In 201.14 - Change the paragraphs on page 152 in lines 45 to 54 to read instead:

Annex 201A Allocation of Delay Limit Budget (Informative)

Figure 201A-1 XGMII to MDI to XGMII Timing Diagram

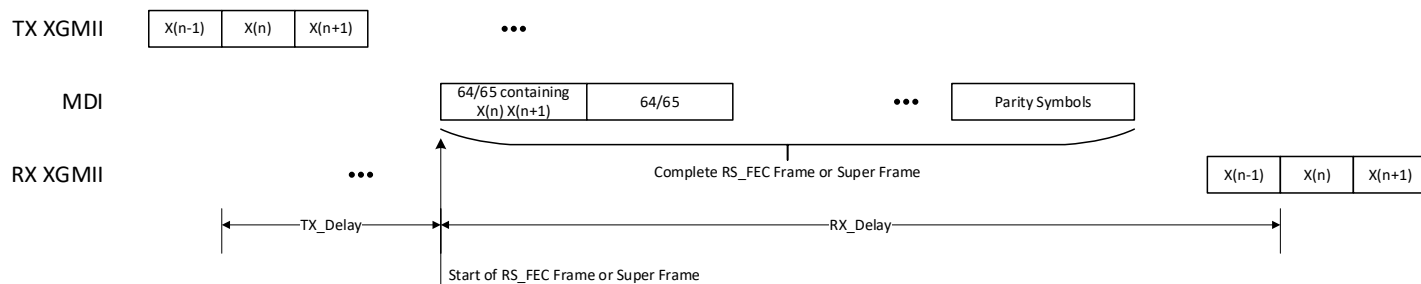
In figure 201A-1, XGMII transfers are shown as X(#) where # is sequentially incrementing. Let the first 64/65 block of a RS frame or super frame contain the X(n) and X(n+1) XGMII transfers.

The TX_Delay is defined from the start of the X(n) transfer on the TX XGMII to the start of the first symbol of the frame or super frame at the MDI.

The RX_Delay is defined from the start of the first symbol of the frame or super frame at the MDI to the start of the X(n) transfer on the RX XGMII.

The HS_PATH delay of 201.14 is composed of the HS_TX TX_Delay in the PHY_S plus the HS_RX RX_Delay in the PHY_D.

The LS_PATH delay of 201.14 is composed of the LS_TX TX_Delay in the PHY plus the LS_RX RX_Delay in the PHY_S.

Besides the MAC Control PAUSE operation (Clause 31, Annex 31B), also the time synchronization support (Clause 90) requires this information for best interoperability between different implementations. It is therefore recommended to allocate the PATH delay portions as follows:

- The HS_TX TX_Delay is allocated 10% of the HS_PATH delay budget of Table 201-24.
- The HS_RX RX_Delay is allocated 90% of the HS_PATH delay budget of Table 201-24.
- The LS_TX TX_Delay is allocated 25% of the LS_PATH delay budget of Table 201-24.
- The LS_RX RX_Delay is allocated 75% of the LS_PATH delay budget of Table 201-24.

Since the start of the first symbol of the frame or super frame is not accessible easily at the MDI, it is recommended for the PHY implementers to specify TX_Delay and RX_Delay in the product's documentation and keep their variation low.
